Revision of Manuscript Number: IEEE-TPWRS-01391-2021, version 1 January 9, 2022
Journal: IEEE Transactions on Power Systems
Author: Abhishek Halder, Kenneth F. Caluya, Pegah Ojaghi, Xinbo Geng

Response to decision:

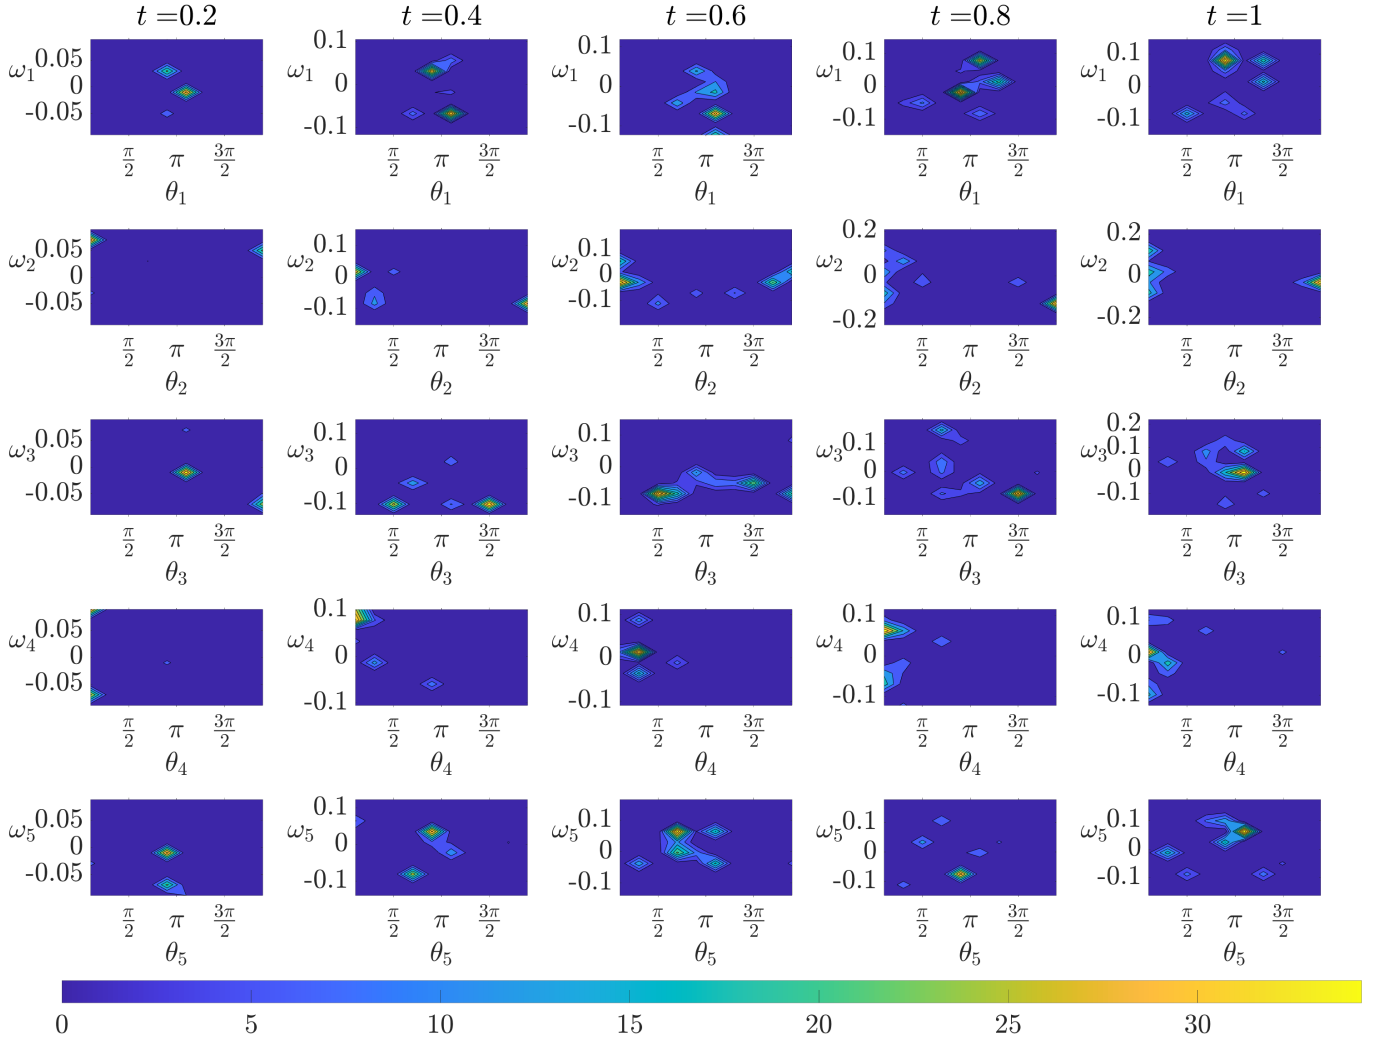
Figures 5 and 6 are unreadable.

Regarding the style of plots, we had considered plotting the bivariate marginals as planar contour plots (as in Fig. 1 in this rebuttal document) but decided against it because of the following two reasons.

Response: Thanks for this comment. In the previous version, the strict 10 page limit enforced small figure sizes. In the revised manuscript, Figures 5 and 6 are made larger. Also, the Fig. 6 in the revised manuscript shows the transient (θ_i, ω_i) bivariate marginals for all the five generators in Case II; the previous version showed the same only for the generator 4 (bus 6). We believe these changes have improved clarity.

First, in our opinion, this kind of plot is scientifically misleading as they hide the fact that these bivariate marginal PDFs are not really supported on the plane, or the subsets thereof, but instead have cylindrical supports. Our message that the proposed method explicitly accounts this manifold geometry in the computation, would be missed had we chosen to make the plots as per populist cognitive bias on behalf of the readers. That the planar plots evoke a sense of familiarity cannot be a scientific argument in favor of it.

Second, the planar contour marginal plots require additional mental efforts from the readers to correctly parse the statistical information conveyed. For instance, consider the fourth column, second row subplot in Fig. 1 in this rebuttal document. It is upon the reader to parse that the two high probability regions on the left and right of that subplot are actually referring to the same angular high probability region around $\theta_2 = 0$ rad, thanks to the periodic boundary condition on the angular variable. Our philosophy of technical communication is that the onus is on the authors, not on the readers, to clarify the scientific information as correctly as possible. And yes, we are aware that many papers in the power system literature make plots in the rectangular domain ignoring the manifold nature of the support, which in our experience, continue to add pain to the graduate students and beginning researchers trying to decipher the statistical meaning conveyed in those plots. We thus prefer to make plots that depict the variables as they are.
